App. S/N: 09/815,520
Filing Date: 03/23/2001
Amdt Date: 08/11/05

AMENDMENT AND RESPONSE
TO NON-FINAL OFFICE ACTION

Examiner M. Scott Lowe
Group Art Unit: 3652
Confirm. No.: 8098

Figure 17

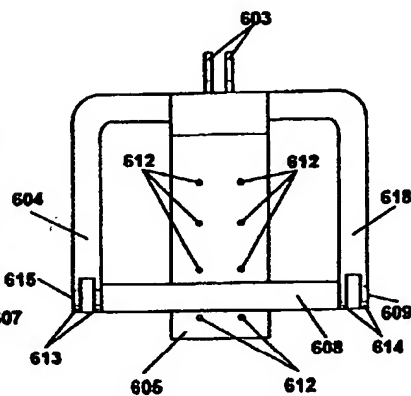
1. In paragraph 1, the Examiner indicated that the "drawings are objected to because some of the figure headings are spelled wrong." The applicant has included with this response amended figures 1, 13 and 17 correcting the spelling of the figure headings. The applicant has included annotated drawing sheets showing the changes made. The applicant believes that these amended drawings and these comments are fully responsive to the objection of this paragraph. Accordingly, the applicant respectfully requests reconsideration and withdrawal of this objection.
